Design Requirement to Move From SX Rev.2.1 to Rev.2.5

This memo talks about the necessary board design change to move from SX Rev.2.1 to SX Rev.2.5 parts.

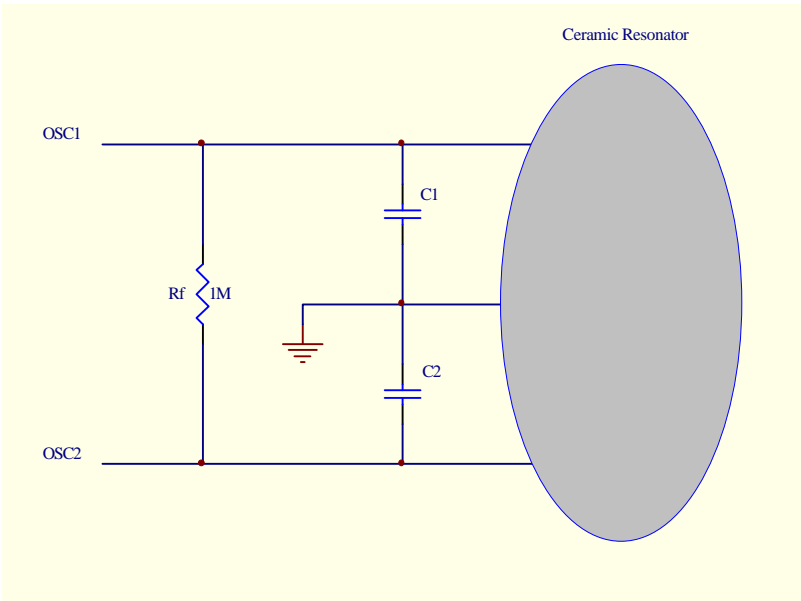
1. Rev 2.1 has internal feedback resistor between OSC1 and OSC2 pins. To switch to Rev. 2.5 parts the feedback resistor for the oscillator circuit should be provided externally. The following tables give the values of the resistors and capacitors for the clock oscillator circuit for Rev. 2.5 parts.
2. In-system Debugging (ISD) is not supported with Rev.2.1 parts, but it is supported with Rev.2.5 parts. To do ISD with SX-key and Rev. 2.5 parts, it is required to remove the clock circuit from the board. In-system programming (ISP) is supported with both 2.1 and 2.5 Revs, and no clock circuit removal is necessary.

Resistor & Capacitor Selection for Ceramic Resonator (RF = 1M)

Osc Type	Resonator Frequency (MHz)	C1(pF)	C2(pF)
XT	455 kHz	20	100
	2	20	47
	4	20	47
HS	8	20	47
	10	20	47
	12	20	47
	20	5	15
	50.0 without Caps	5	10
	50.0 with Caps	No Cap	No Cap

Resistor & Capacitor Selection for Crystal

Osc Type	Crystal Frequency (MHz)	C1(pF)	C2(pF)	RF
XT	4	20	47	1M
HS	8	20	47	1M
	12	20	47	1M
	16	15	30	1M
	20	15	30	1M
	25	5	20	10K
	30	5	20	4.7K
	36	5	15	3.3K
	40	5	15	3.3K
	50	5	10	3.3K
